TFO AND DFO RESPONSES TO AESO IRs

Re: Fortis Lethbridge Reliability

**Re: Lethbridge Area – AESO Project P2123
Information Requests to FortisAlberta Inc.**

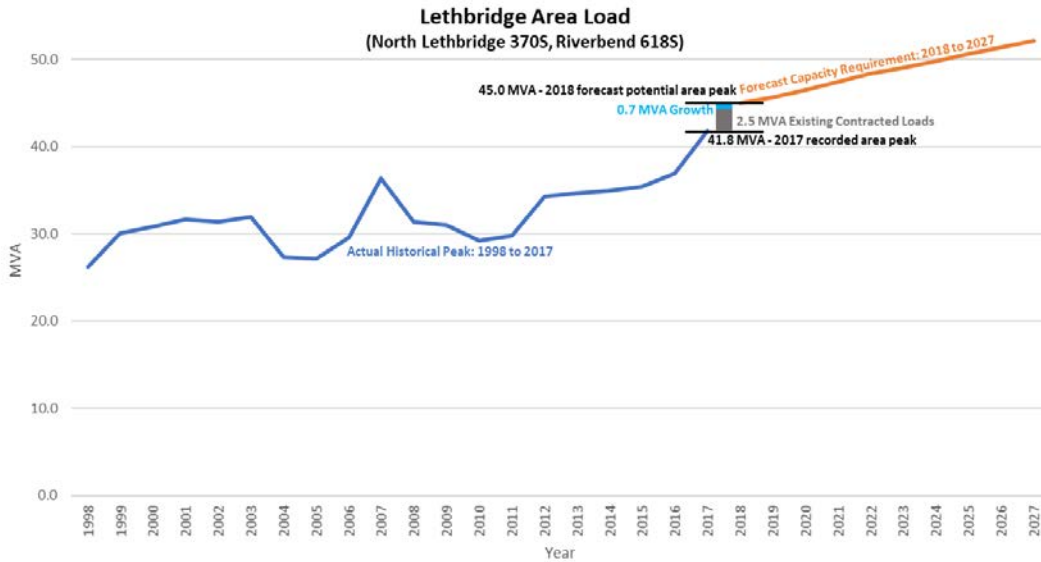
Please explain the source (e.g. organic growth vs discrete load addition) and type of forecast load growth in the area (2018-2027), as shown in the NFD (refer to section and table 4-1). Please provide a rationale for the load increase from 2017 actuals to 2018 forecast.

The following graph illustrates the composition of load represented in the increase from 2017 “Actual” area peak load to 2018 “Forecast” required capacity for the Lethbridge area.
